BID PACKAGE 02 – ADDENDUM 01**Date:** January 10, 2020**Re:** Wilma P Mankiller Health Center Expansion**From:** James R Childers Architect, Inc.
45 South 4th Street
Fort Smith, Arkansas 72901

CHANGE NARRATIVE LETTER

TO: MATHEW THOMAS- CHILDERS ARCHITECTS
FROM: STEPHEN EDMONDSON, TREY SMITH, BETSY WELLS– HP ENGINEERING, INC.
DATE: 1/10/2020
PROJECT: WPMHC EXPANSION BID PACKAGE 02 ADDENDUM 01

SHEET NUMBER:
E2.12
SOUTH SECTOR
1 LEVEL 02
ENLARGED
LIGHTING PLAN

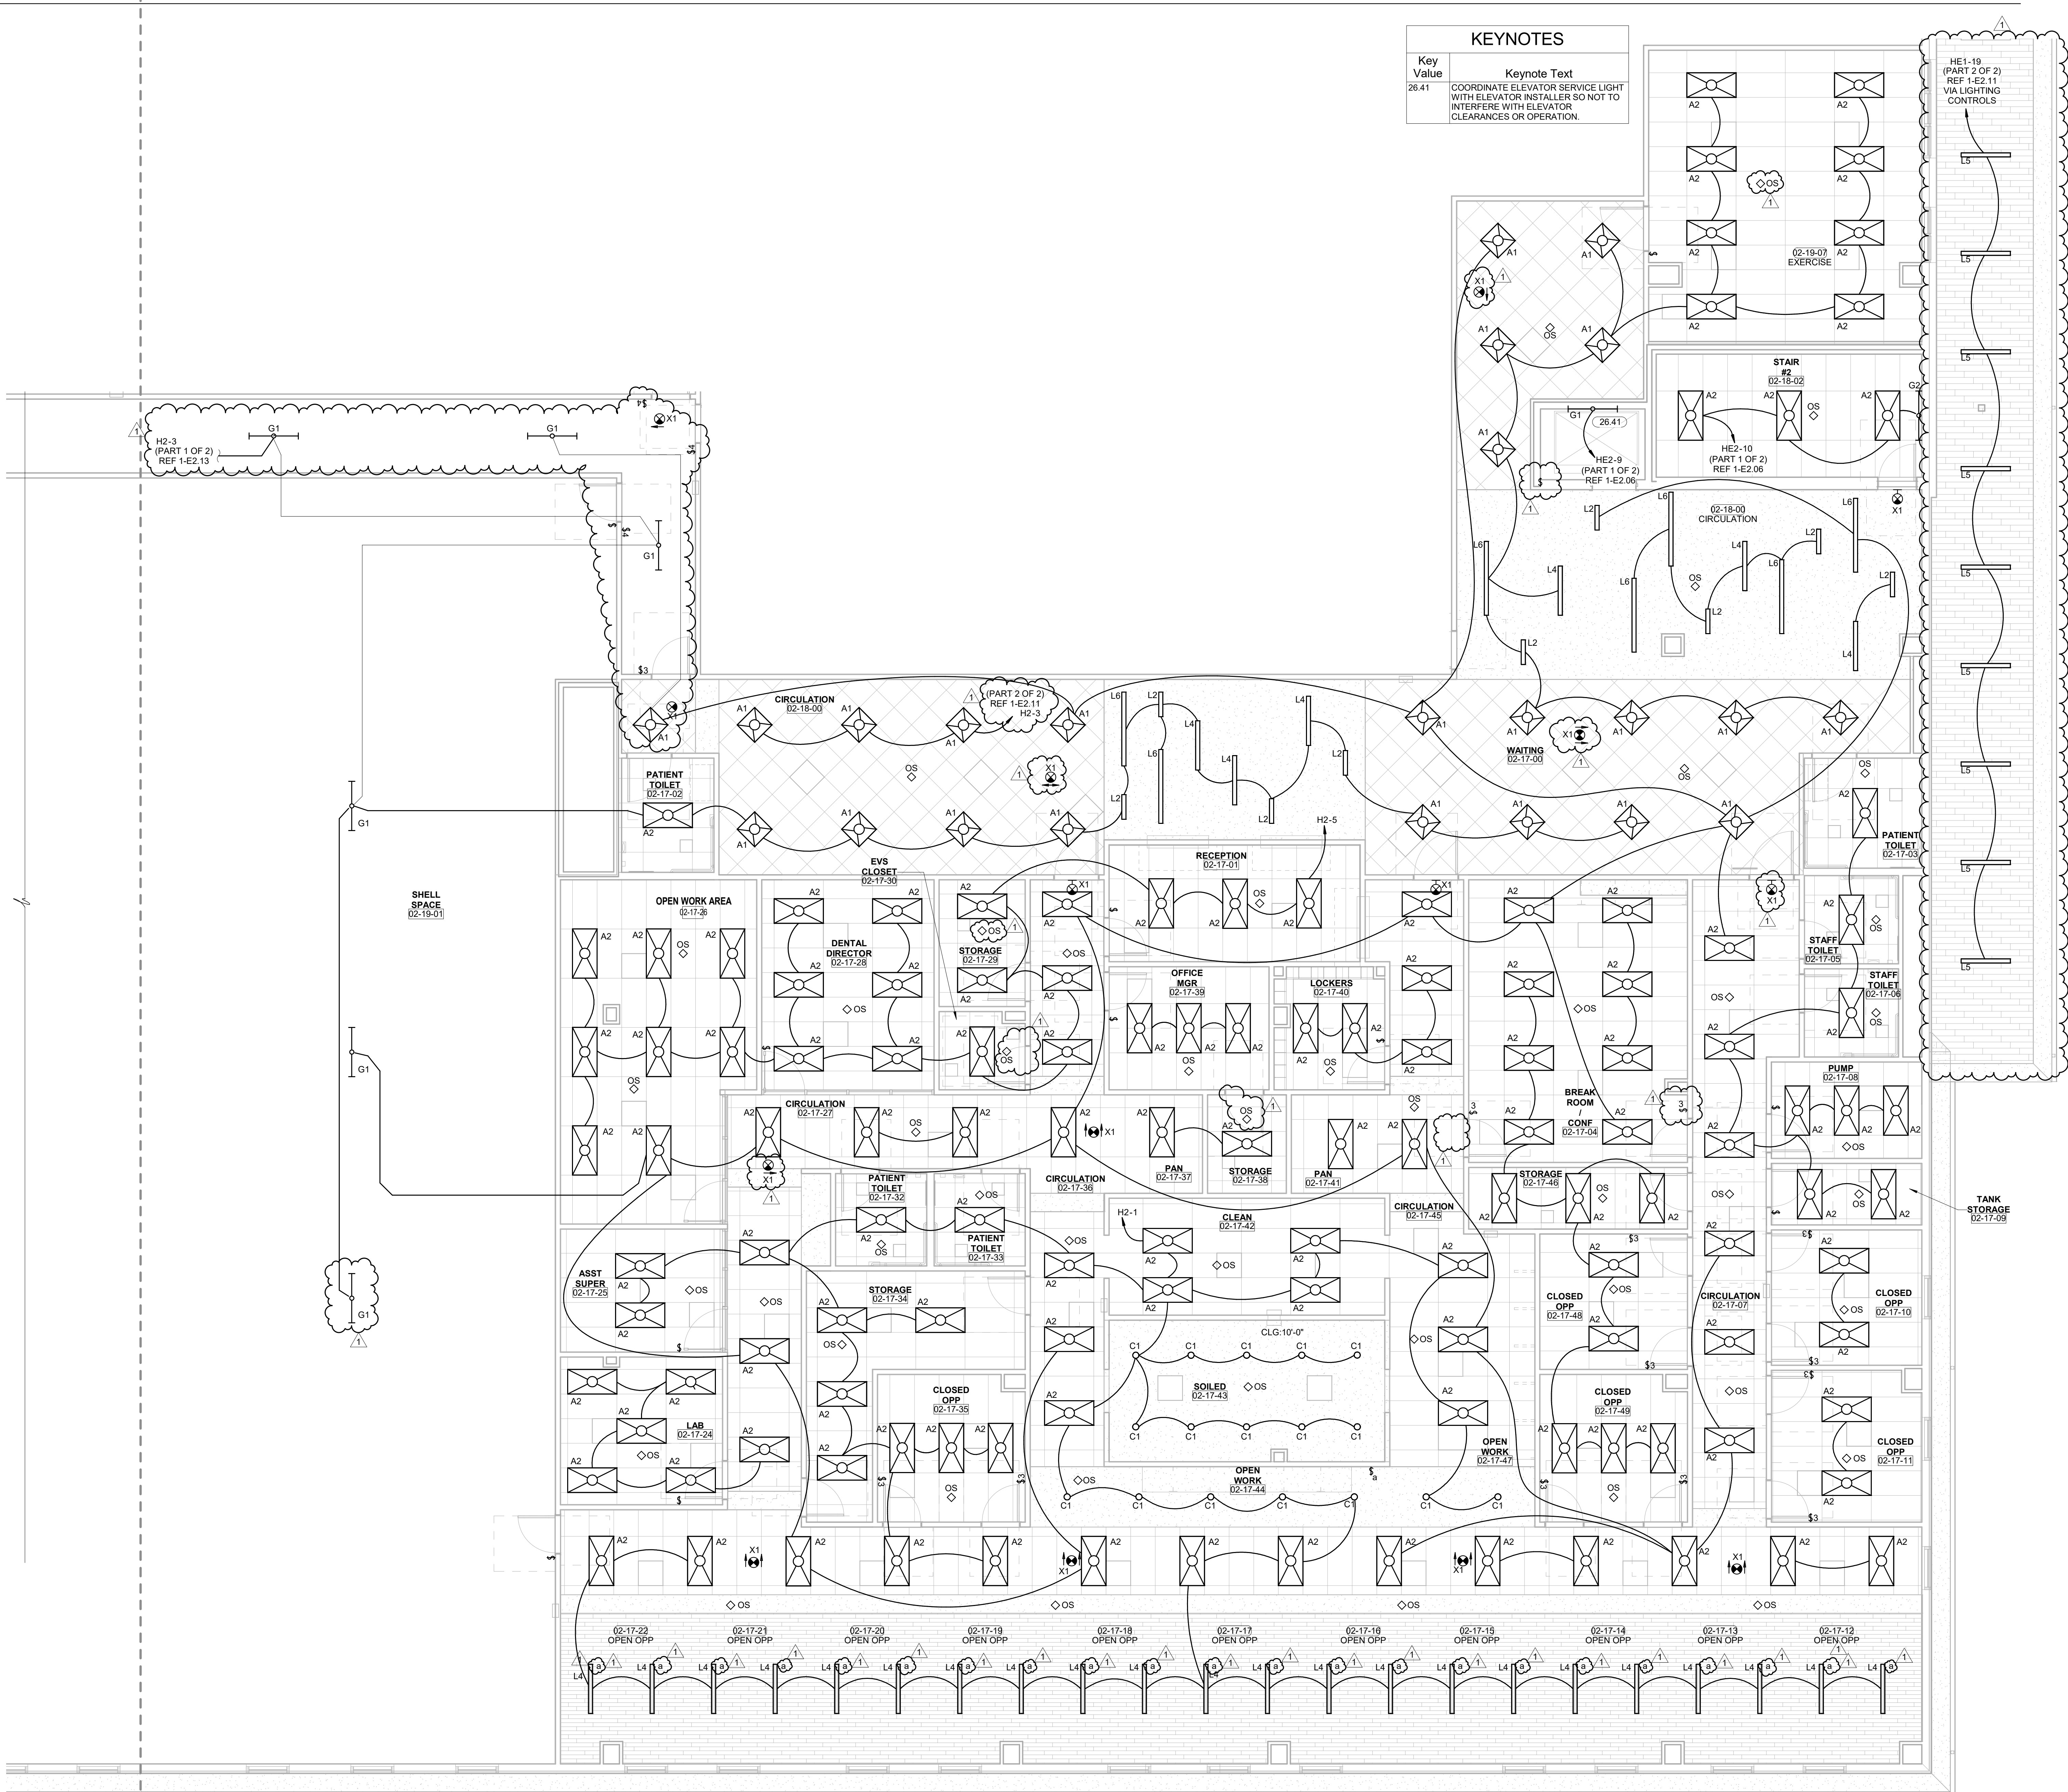
32. E2.12
- a. Detail 1 – Added (11) switches for Open Opp areas.
 - b. Detail 1 – Added (1) Type G1 fixture to Shell Space 02-19-01.
 - c. Detail 1 - Added (1) Type X1 fixture to Circulation 02-17-27.

- d. Detail 1 – Removed wall OS from EVS Closet 02-17-30.
- e. Detail 1 – Added (1) ceiling OS to EVS Closet 02-17-30.
- f. Detail 1 - Added (1) ceiling OS to Storage 02-17-29.
- g. Detail 1 – Removed wall OS from Storage 02-17-38.
- h. Detail 1 – Added (1) ceiling OS to Storage 02-17-38.
- i. Detail 1 – Removed (1) Type X1 fixture from Circulation 02-17-45.
- j. Detail 1 – Revised (1) Type X1 fixture to be wall mounted in Circulation 02-17-07.
- k. Detail 1 – Added (1) Type X1 fixture to Waiting 02-17-00.
- l. Detail 1 – Revised (1) Type X1 fixture to be single faced in Circulation 02-18-00.
- m. Detail 1 – Hallway ceiling has been removed. Hallway fixtures changed to G1 fixture
